**LEGAL ADVERTISEMENT
HISTORIC PRESERVATION BOARD
CITY OF PORTLAND**

**PUBLIC HEARING
392 SPRING STREET**

WORKSHOP
383 COMMERCIAL STREET

WORKSHOP
742 CONGRESS STREET

Hotel Lobby

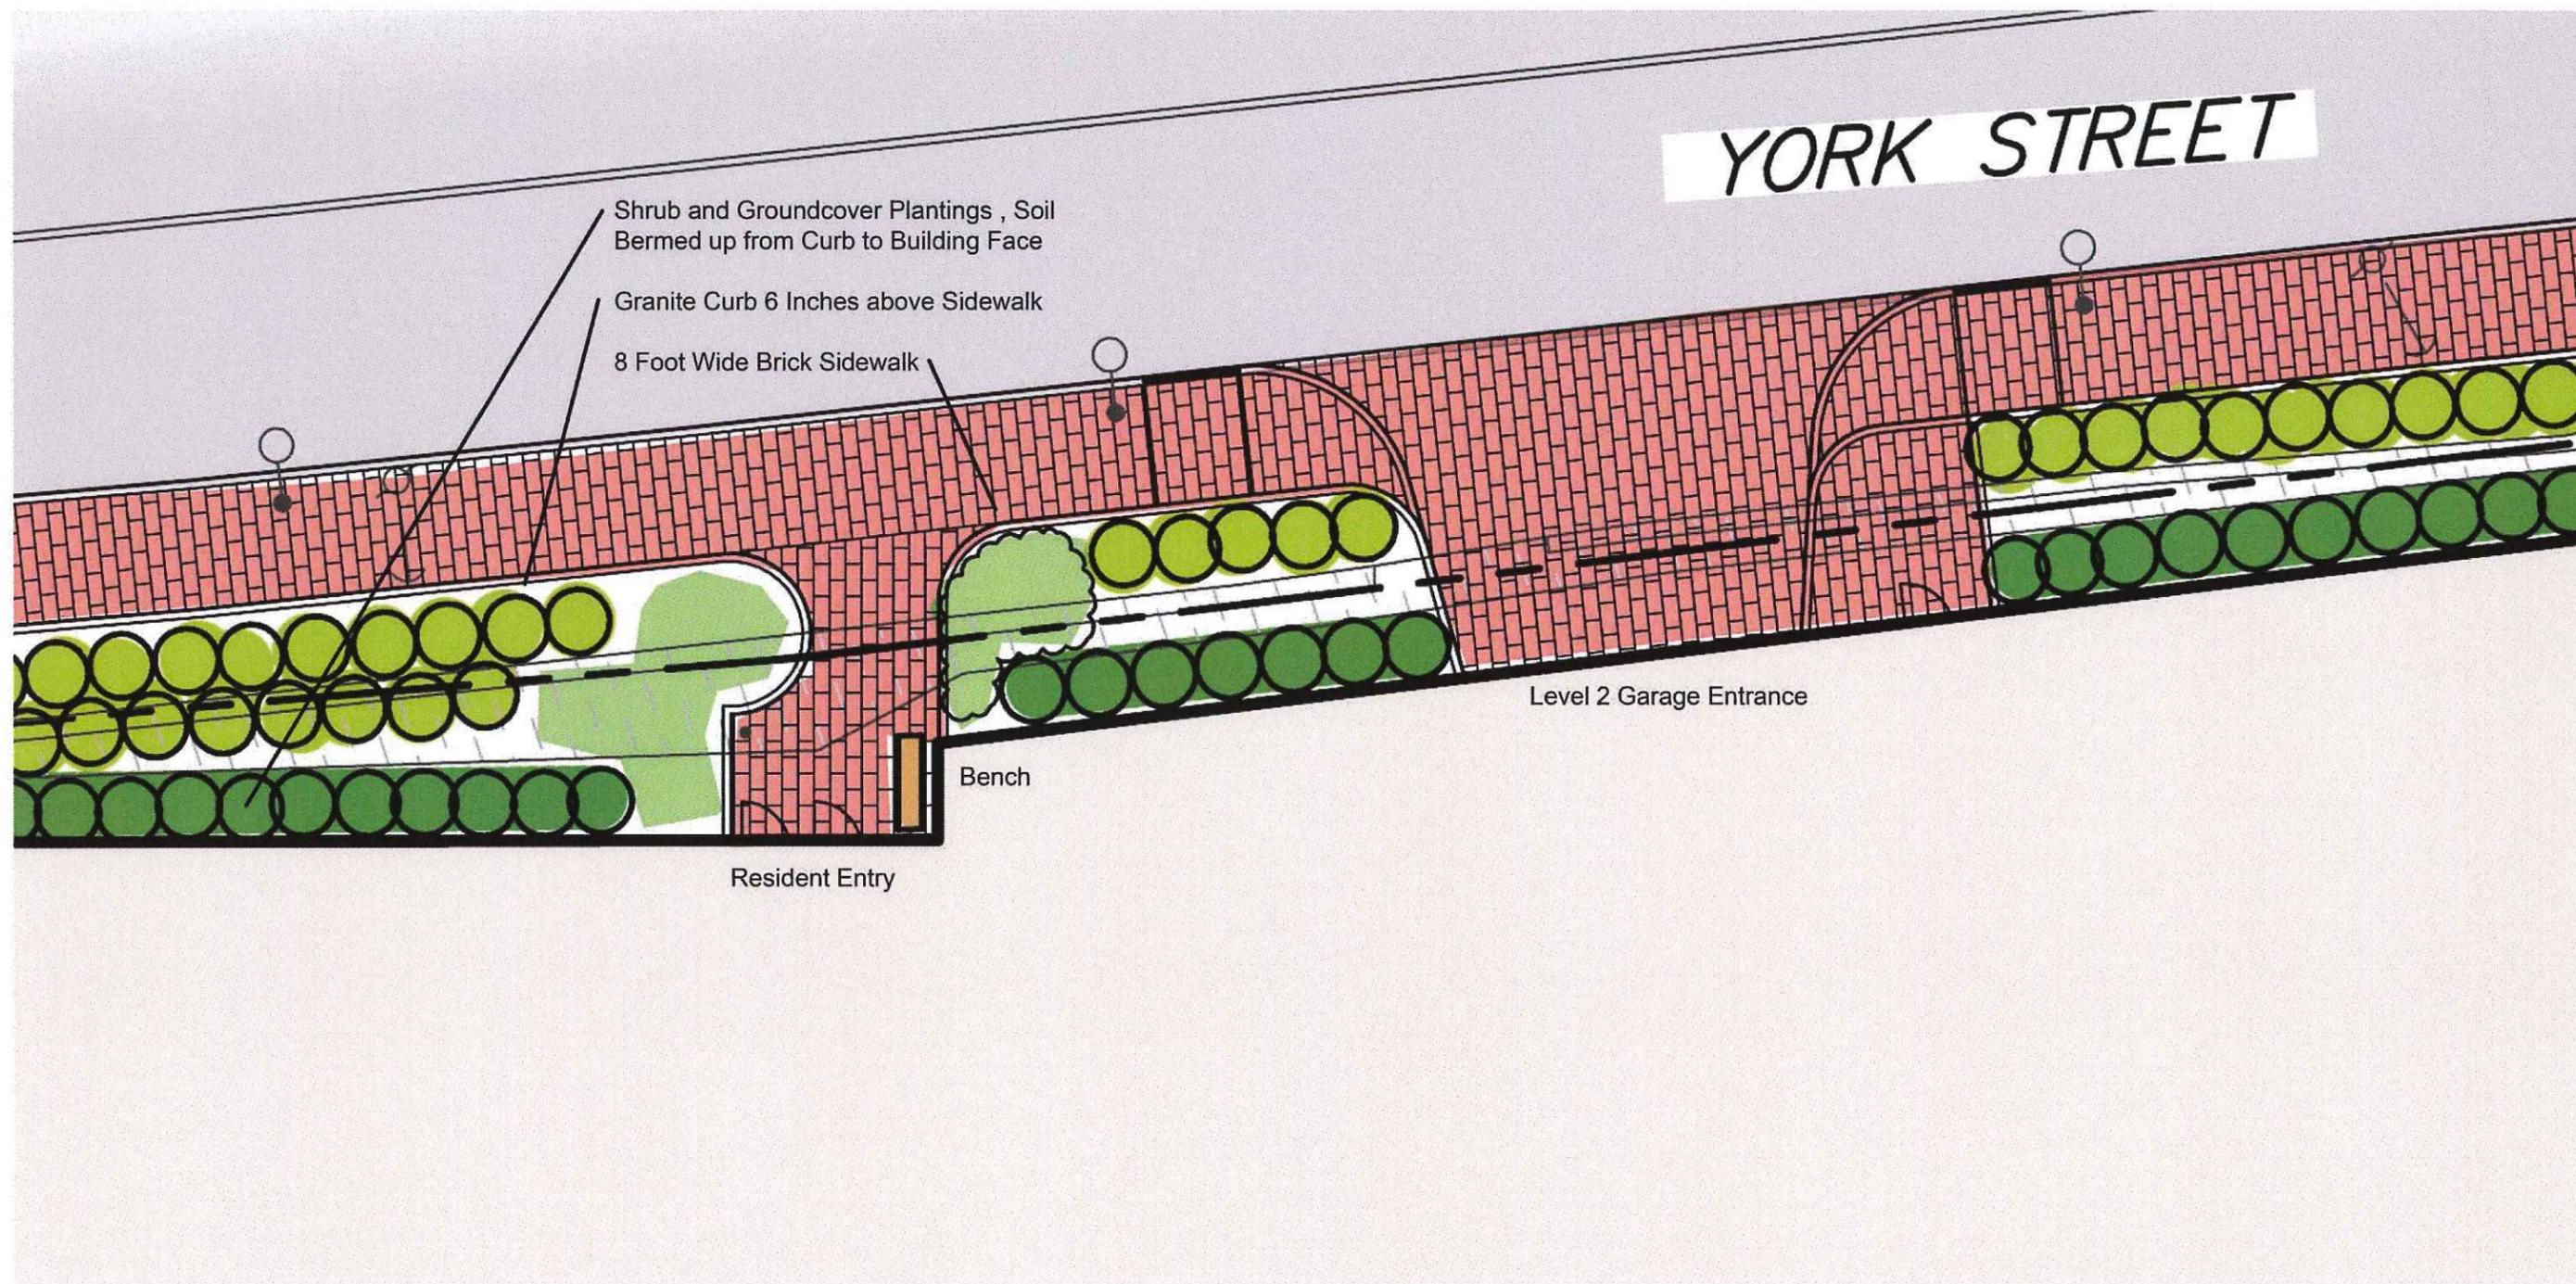
- As noted above, the bridge previously proposed to connect the residential development to the hotel has been eliminated.
- The submission includes a detailed site plan and renderings of the pedestrian passageway separating the two components of the development. Renderings of the passageway from both York Street and Commercial are provided. Note that the change in grade is accommodated by a set of steps and landings located well back from both frontages.

SITE PLAN

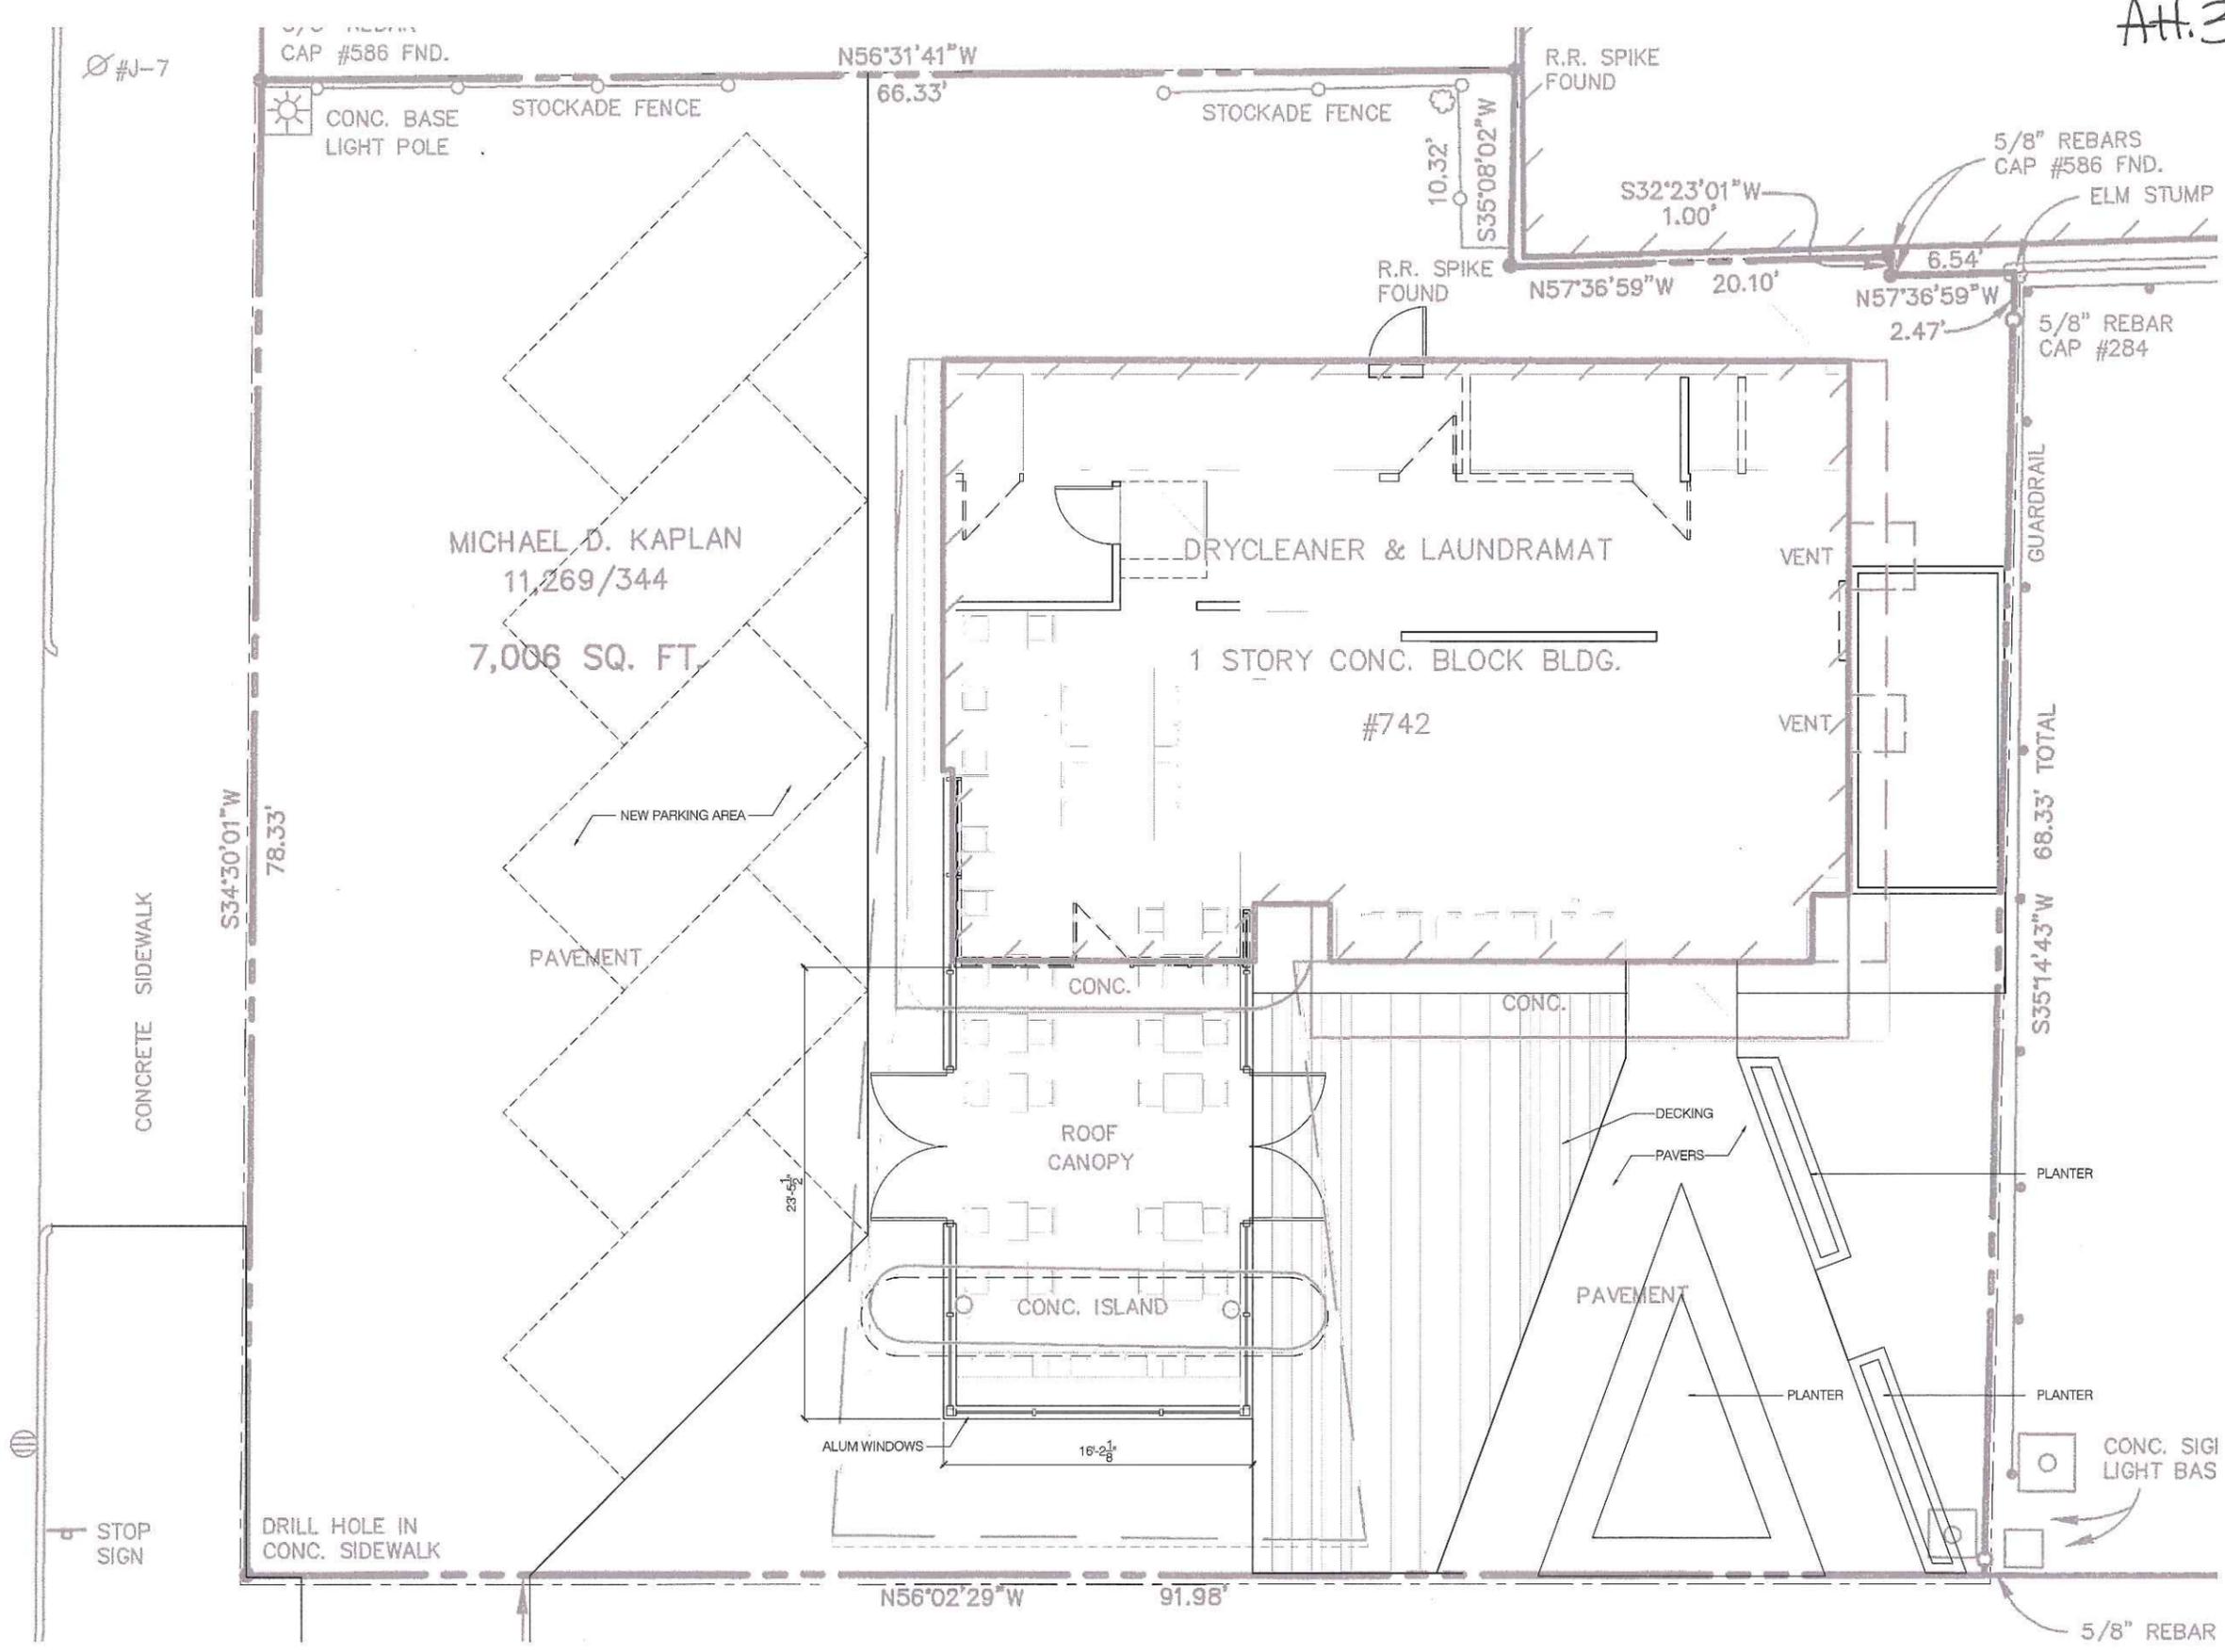
A raised patio or deck is proposed on the west side of the new enclosed space, occupying the inside corner of the two building sections. This deck extends beyond the face of the enclosed room and the leading edge of the canopy itself, terminating at the sidewalk line. The west edge of the deck is angled, corresponding to the angle of a triangular planter in the center of the current paved area. This triangular planter separates two pathways leading back to the main entrance of the building. From the site plan, it appears that the pathways are paved in brick to match the sidewalk. Smaller planters border the westernmost pathway.

- What is the height of the proposed planters and what materials are being considered?
- Is fencing proposed along the western property line, as before?
